**Addendum No. 3 to IFB 24-44**

**Henry Hansen Memorial Park Construction Services**

**Re:** Q & A, Clarifications in Response to City & Engineering Review, and Revised sheets L1.0, L2.0, L3.0,  
L4.0, L5.0, L7.0, L7.2, and L7.4.

L3.0

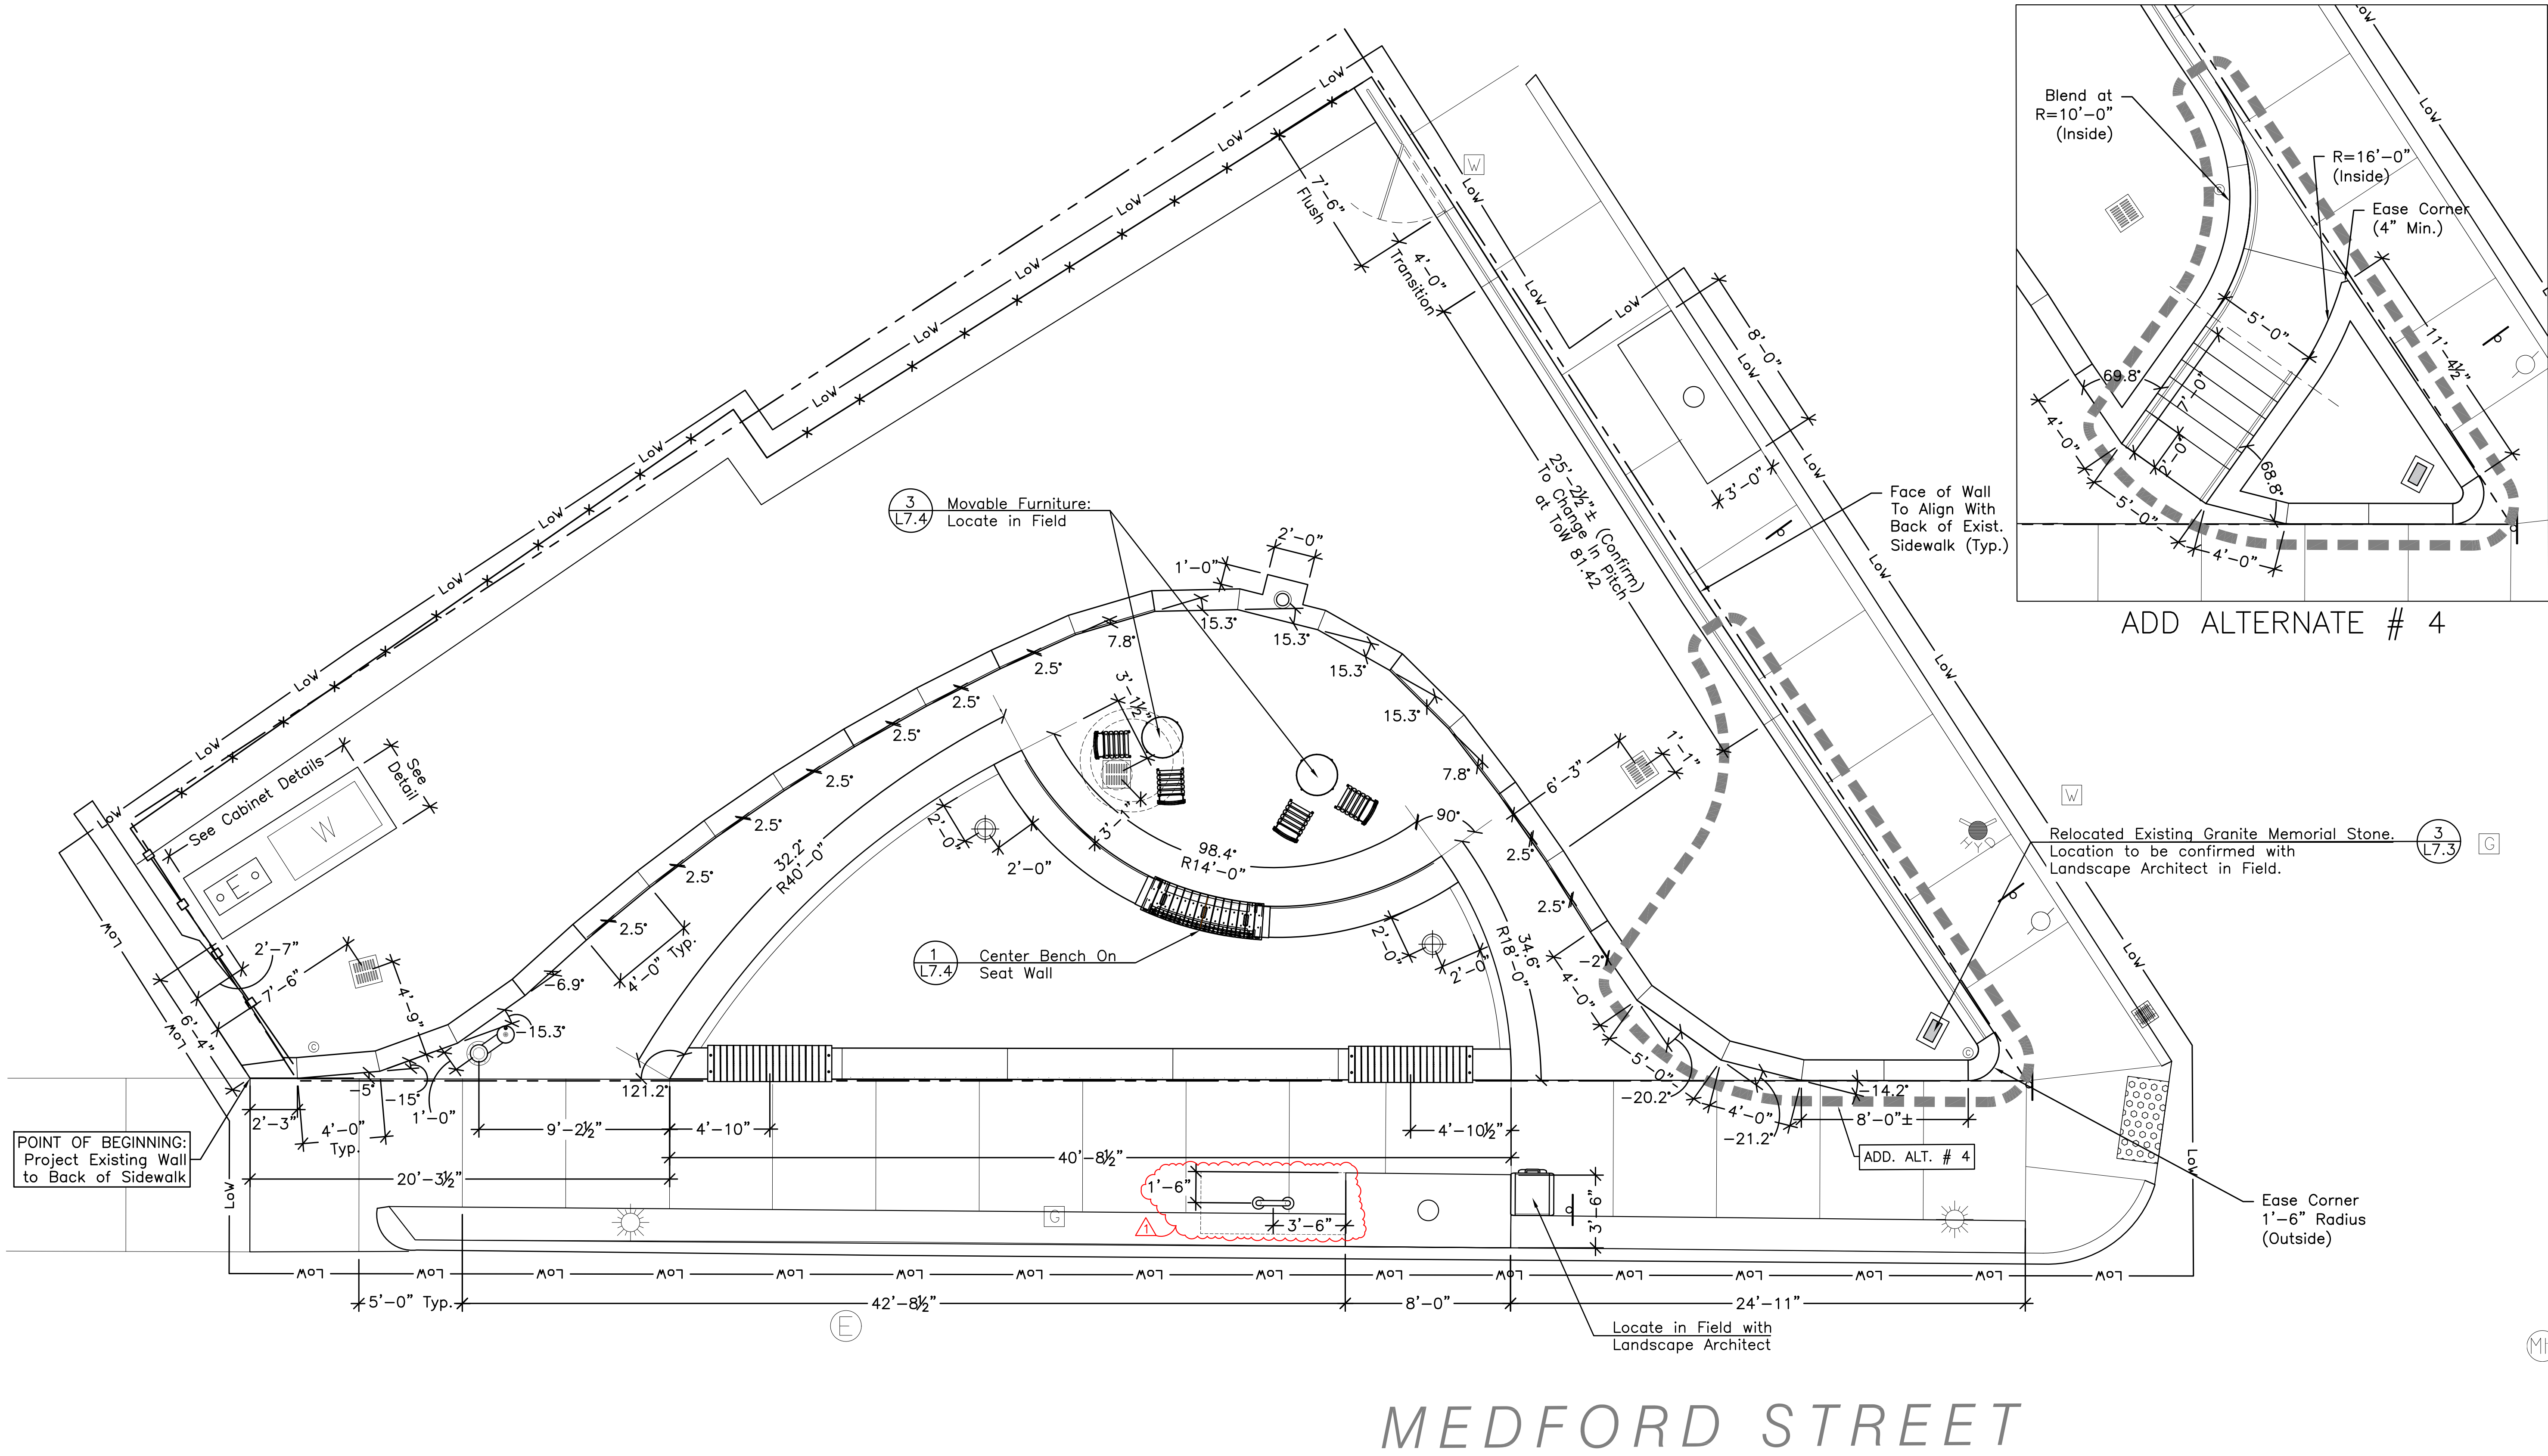
- 4.** There is an existing bicycle rack in the Medford Street sidewalk which was added during the project's design process and not captured on the initial drawings. L1.0, L2.0, and L3.0 have been revised to indicate that the bicycle rack should be removed and relocated (or replaced, should the contractor conclude that that is a less expensive or preferable option). Detail 9/L7.0 has been added to show the reinstallation of the bicycle rack, and it has been added to Section 32 33 00.

## 1 DECORATIVE CASTINGS AND GRAPHIC PANELS ON CURVING CONCRETE RETAINING WALL

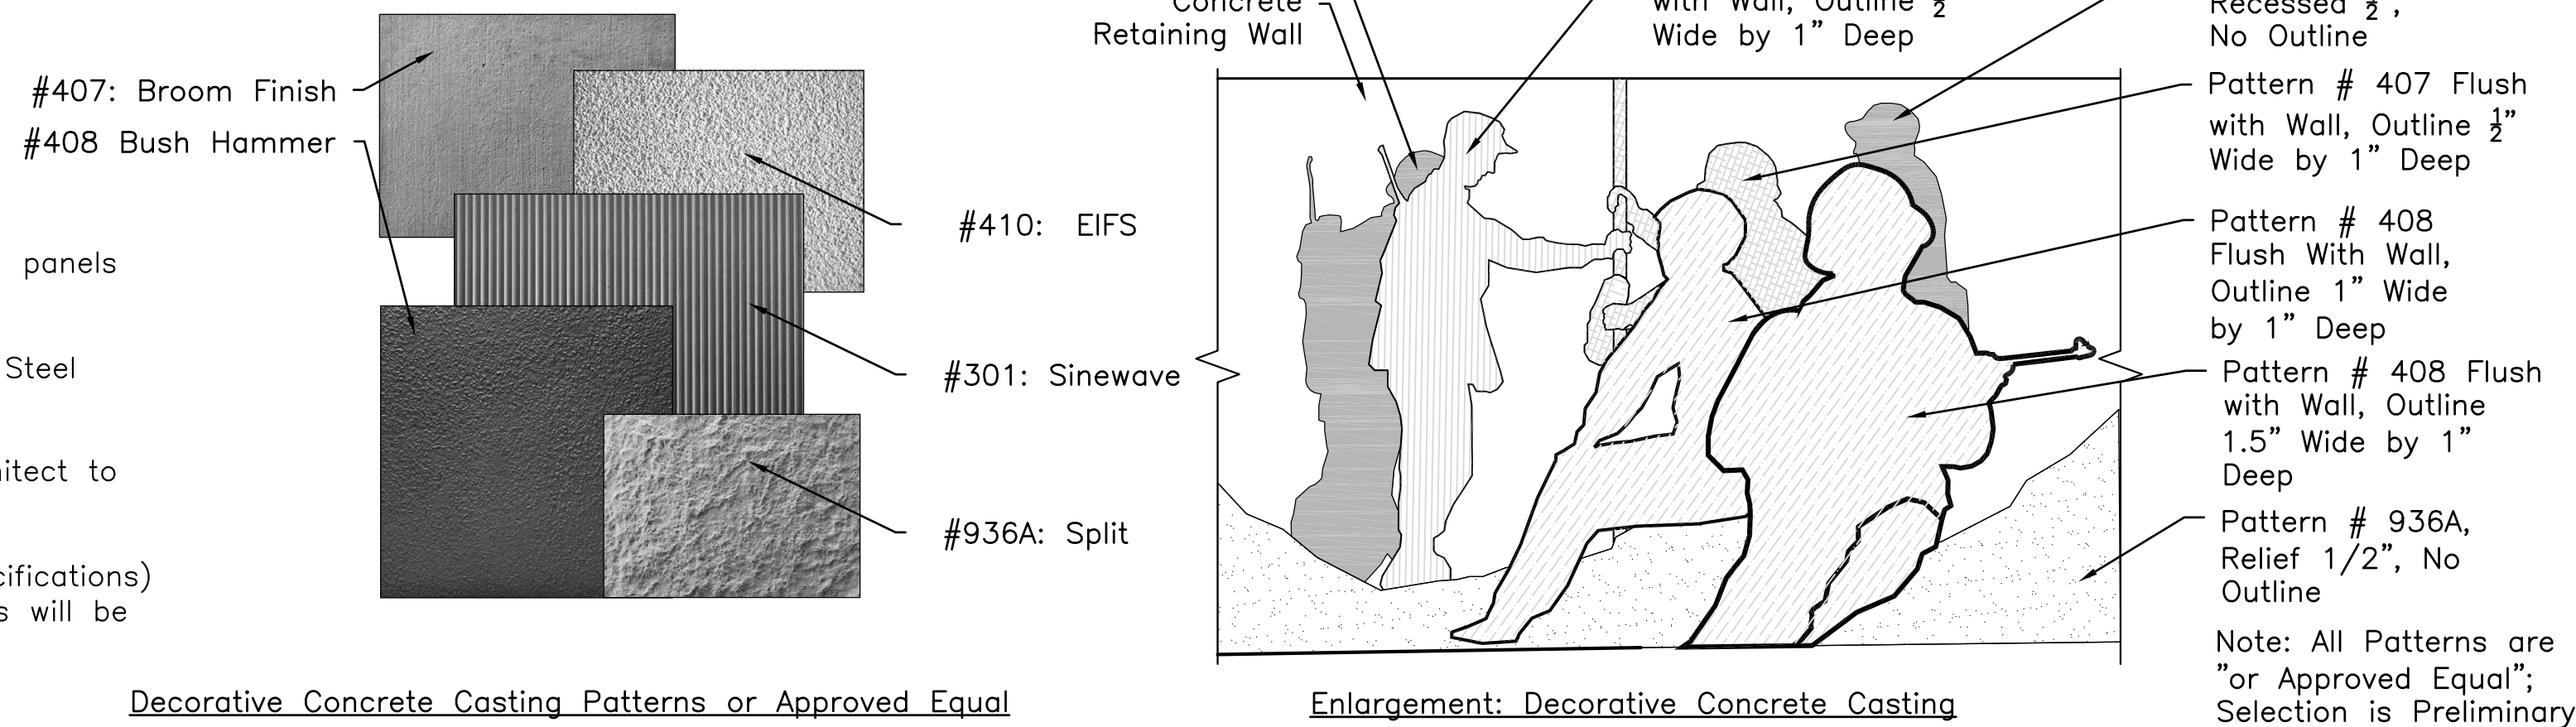
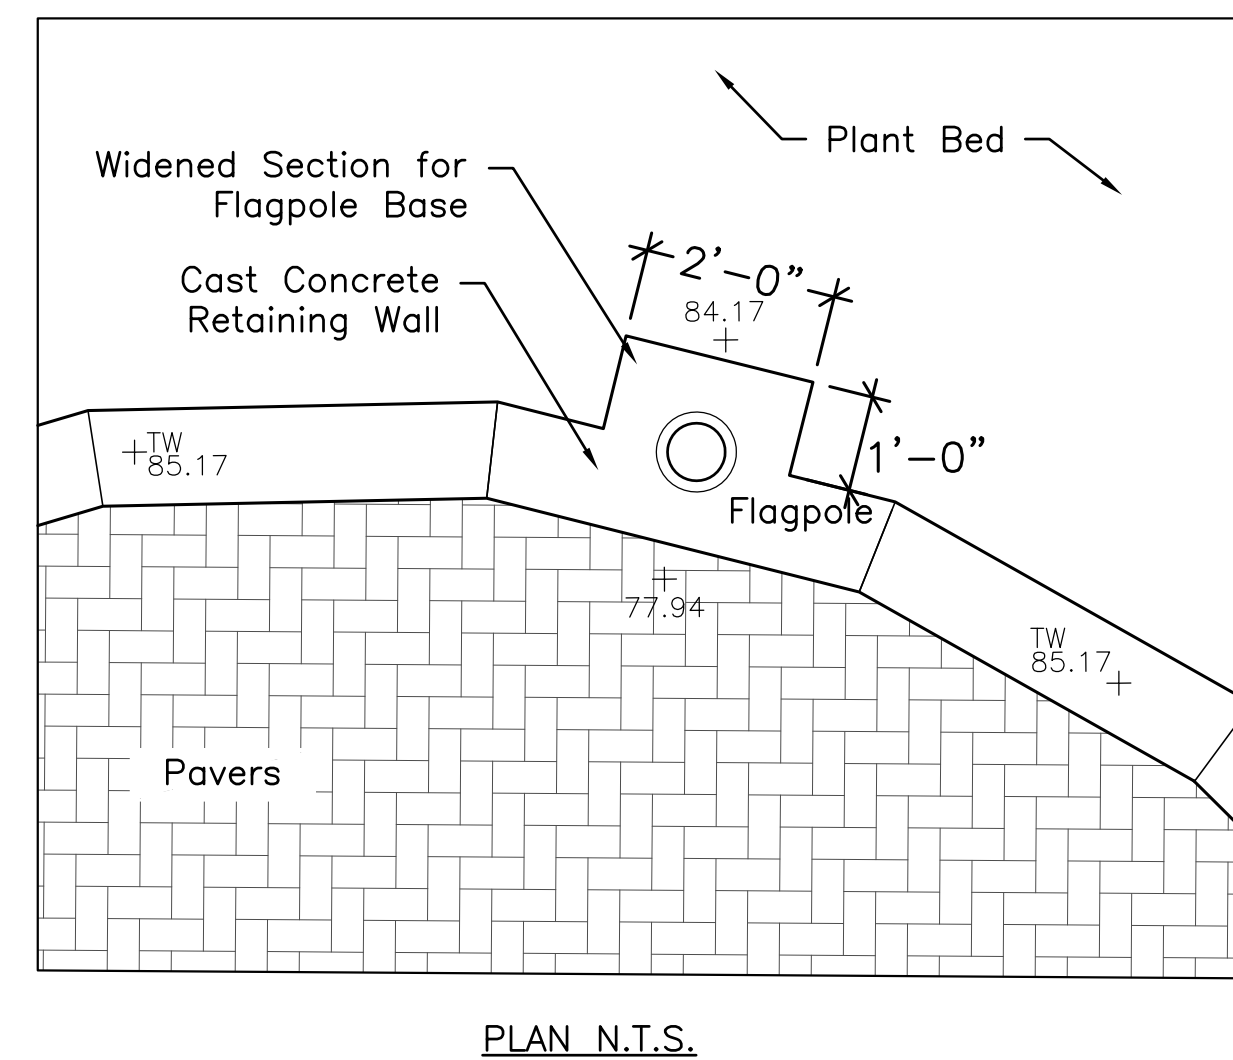
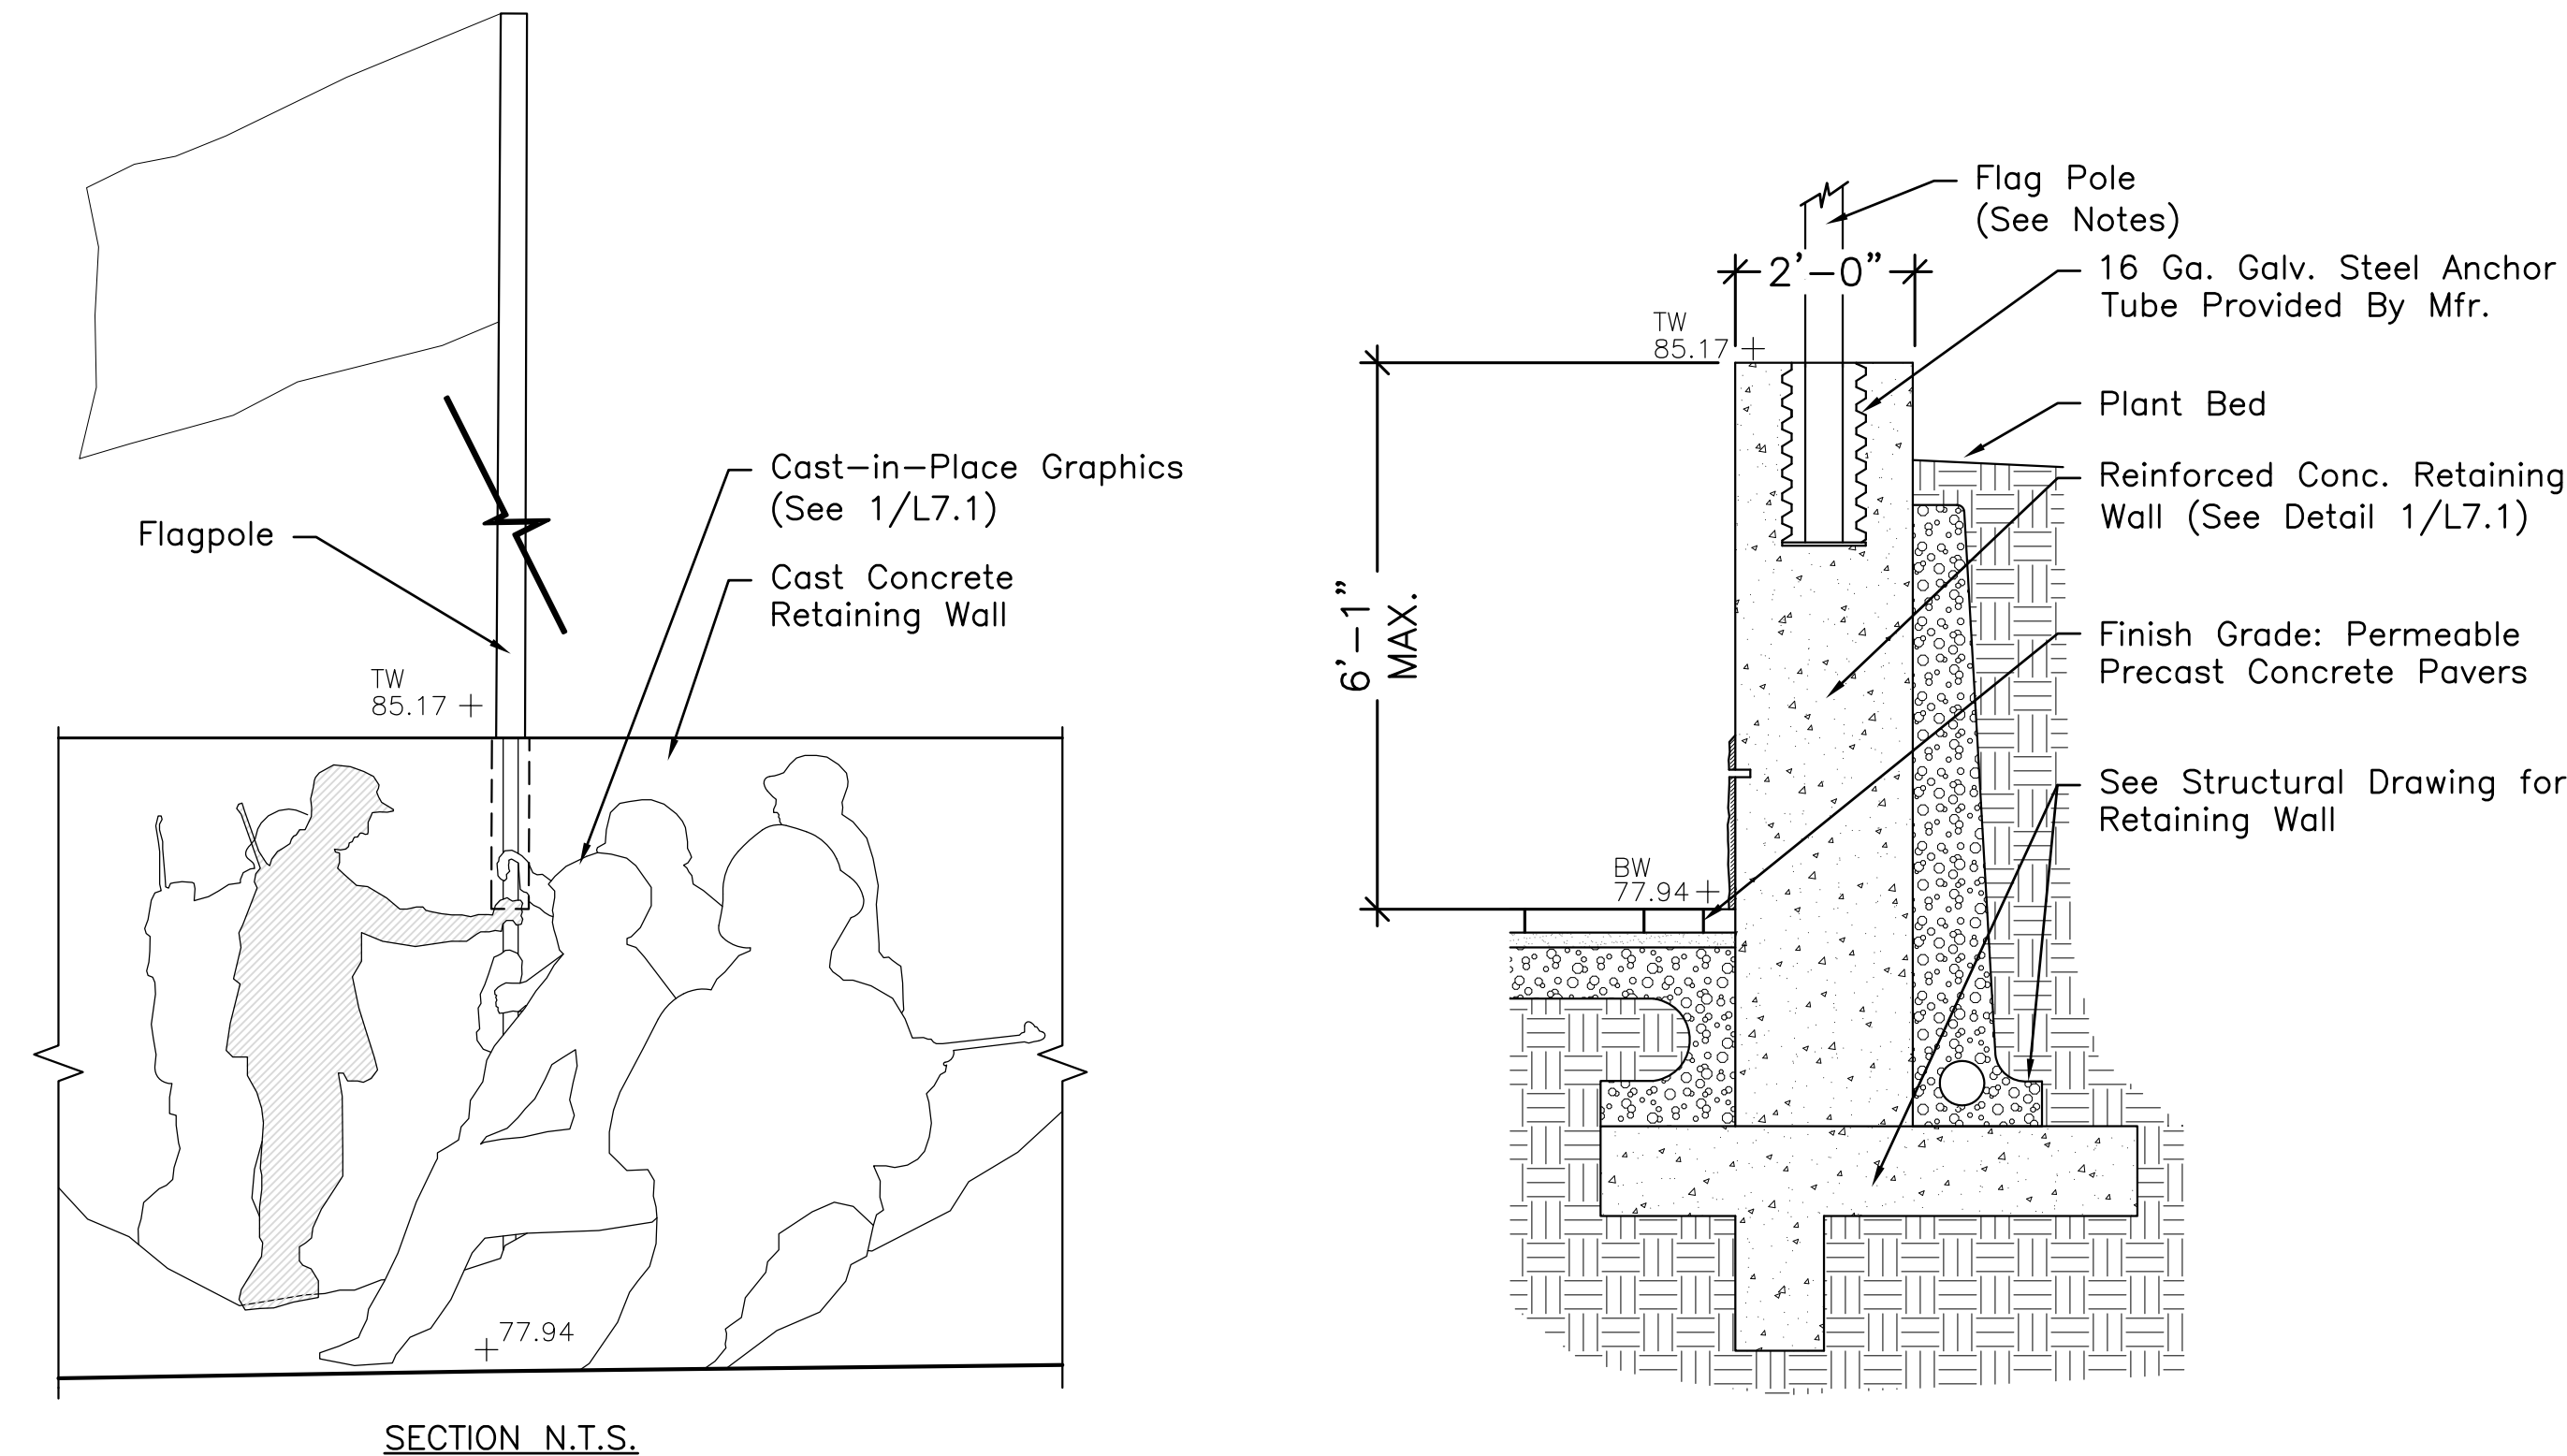
**Q1. Our concrete subcontractor ... would like to know where we obtain a copy of the pattern for the soldiers.**

**A1.** The detail and specifications clarify the intent of the formliners. They list the basis-of-design product for the formliners to establish the minimum standards, and the specifications and the detail's notes clarify that the assumption is that the designer will provide a CAD template to the selected supplier, whoever it is, and work with the supplier's standard patterns, assuming they're acceptable, to finalize the setup. The detail drawing itself shows the current layout of manufacturers' standard patterns, recesses and relief levels, and general arrangement, which establishes the expected level of detail and complexity; the exact design and pattern selection will be based on working with the selected supplier.
